Millstone MSPI FAQs:

Figure 1

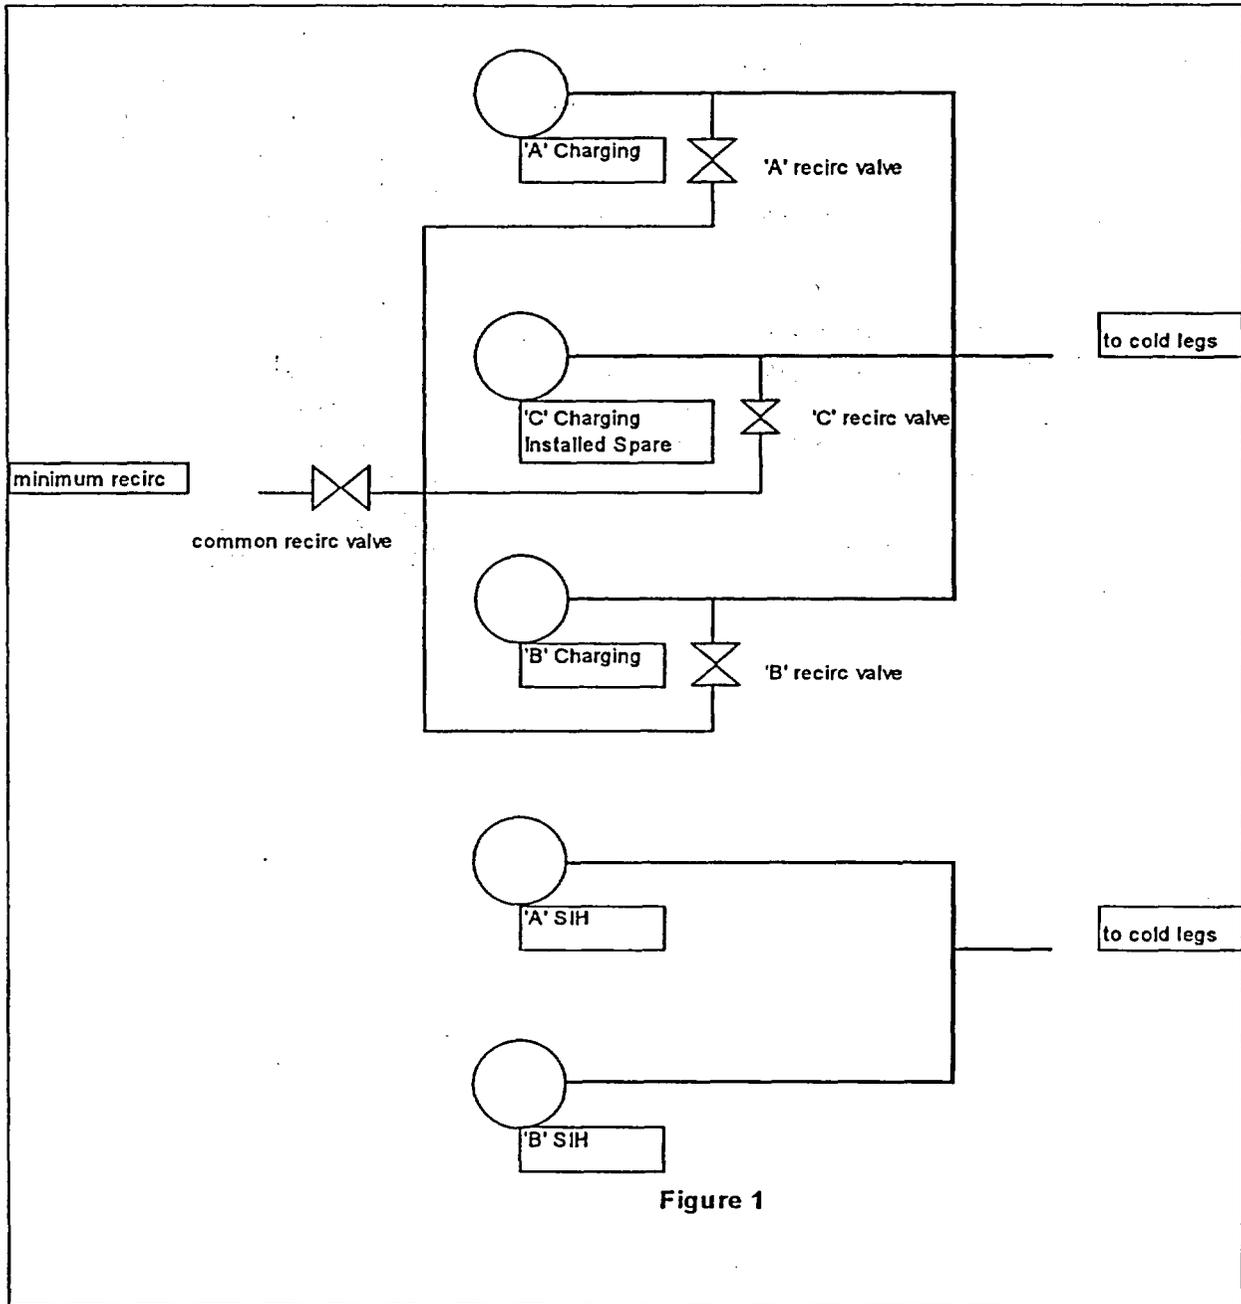
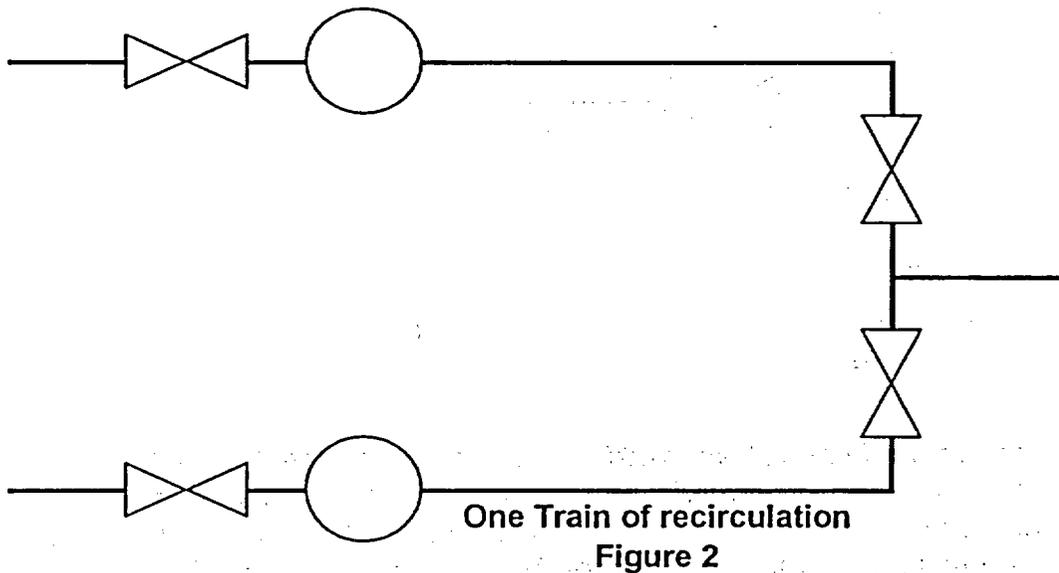
- a) MP3 has three charging pumps. To meet the accident condition flow requirements the recirculation line for a CCP must be isolated. Each pump has one MOV on the its recirculation line. There is an additional MOV on the common line (Figure 1). Therefore for each pump either the common MOV or the branch line MOV must go closed. If the branch line MOVs and the common MOV do not close, all trains are lost. *The success criteria for HPSI is 2 of 4 high head pumps taking suction from refueling water storage tank injecting into 3 of 4 RCS cold legs (or 3 of 3 intact RCS cold legs).* Would these valves be considered active?

Proposed Response: *The charging minimum recirculation valves would not be considered active valves. This system may be considered a four train system. Failure of any single valve does not result in the failure of any train. There are no combinations of two valve failures that result in the failure of the system. Failure of combinations of two valves can only result in the failure of a single train. Therefore the valves may be considered redundant and are not considered active valves.*

Figure 3

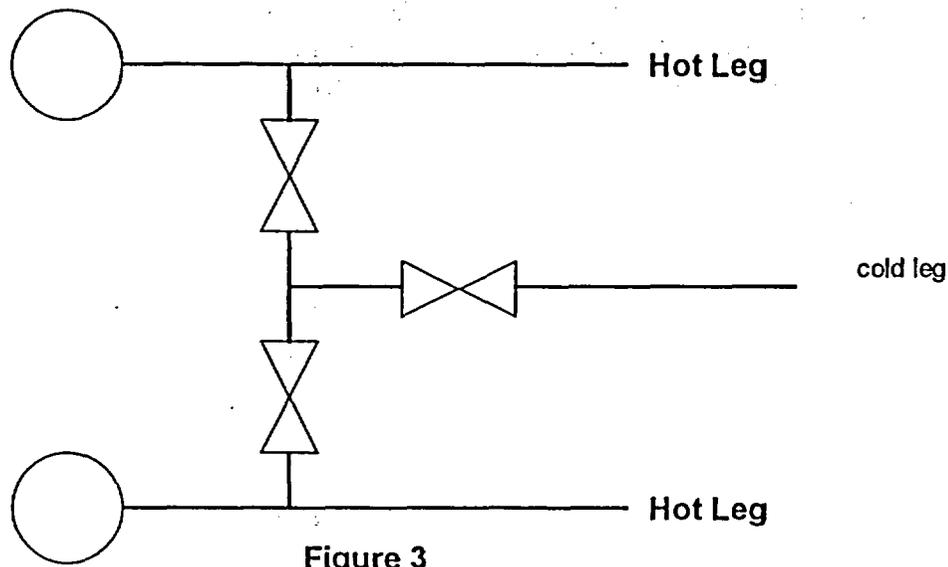
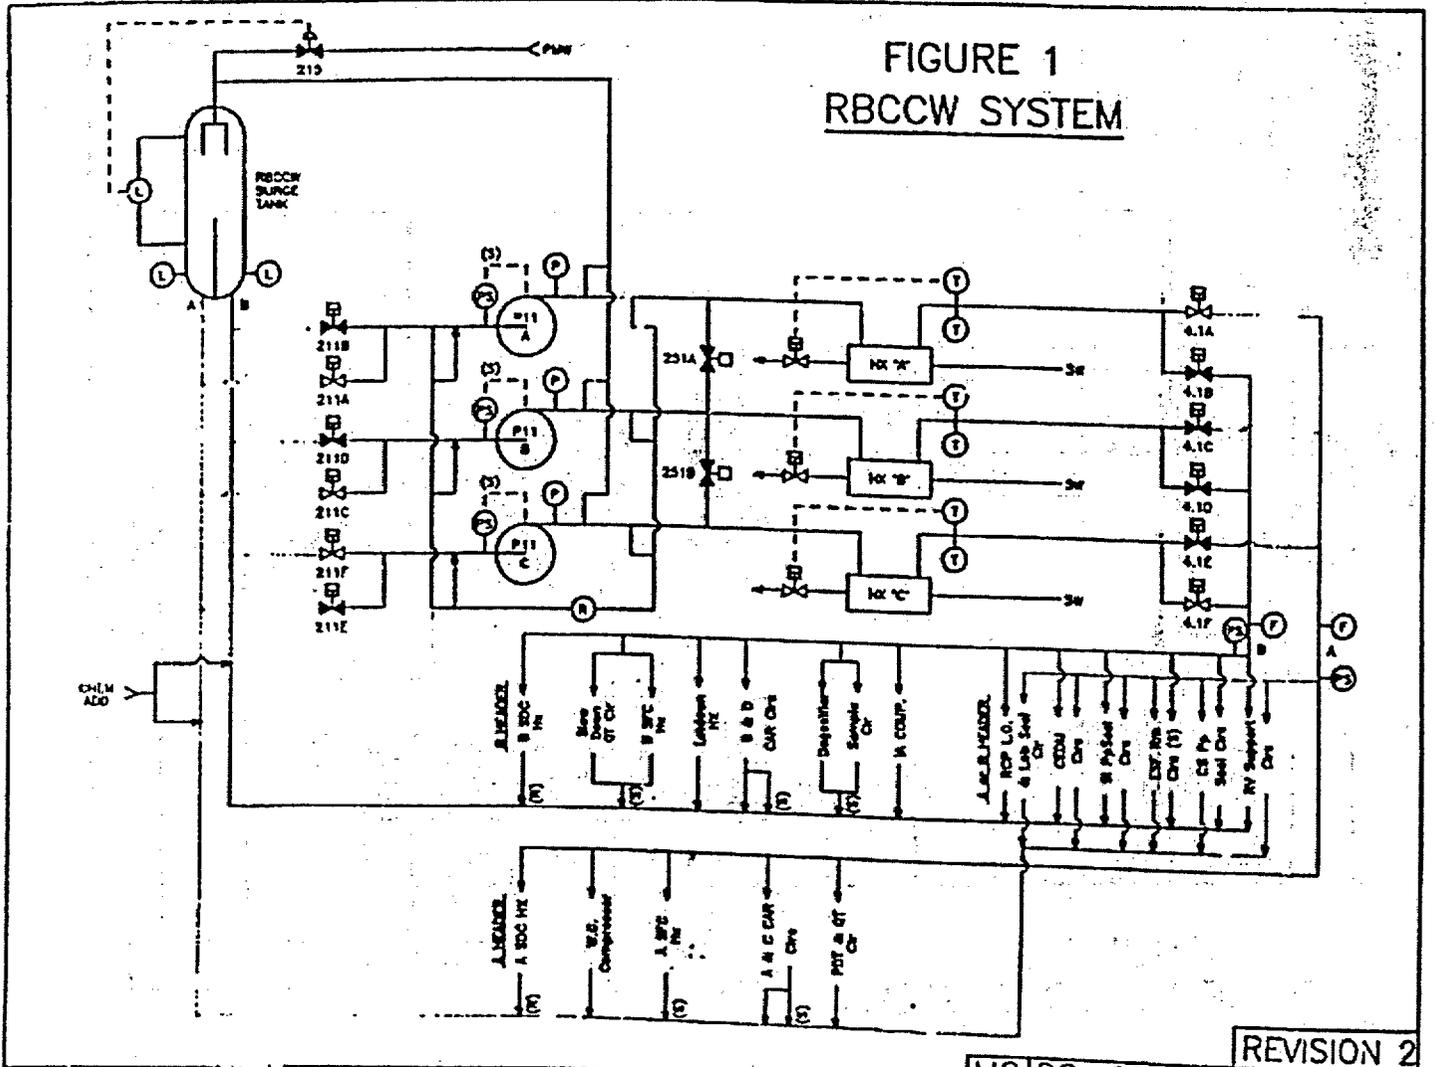
- c) At MP3 there are two trains for hot leg injection. Each train has a MOV in its discharge line to the cold legs and there is also a MOV in the common line to the cold legs. These MOVs are open during normal operation and therefore do not need to change position for cold leg injection or recirculation. During switchover to hot leg injection, the discharge MOV to the cold legs is closed and the hot leg injection MOV is opened for one train and then the other train and then the common cold leg MOV is closed. To meet the hot leg injection requirements either the two discharge MOVs or the common cold leg MOV need to be closed. The PRA success criteria for cold leg injection is for HPSI is 2 of 4 high head pumps taking suction from refueling water storage tank injecting into 3 of 4 RCS cold legs (or 3 of 3 intact RCS cold legs). The 4 trains consist of 2 charging and 2 SIH. PRA does not model hot leg injection (although they do think they should and will update it in the next model revision independent of MSPI) so there is no PRA success criteria. Design Basis would require one of 2 SIH trains because it is assumed that the other is lost due to loss of power on one train. Would these valves be considered active?

Proposed Response: These valves would not be considered active valves. This is considered a two train system. Failure of any single valve would not result in the failure of a train. Failure of any combination of two valves would at most fail one train only, but not the system. Therefore the valves may be considered redundant and are not considered active valves for the MSPI.
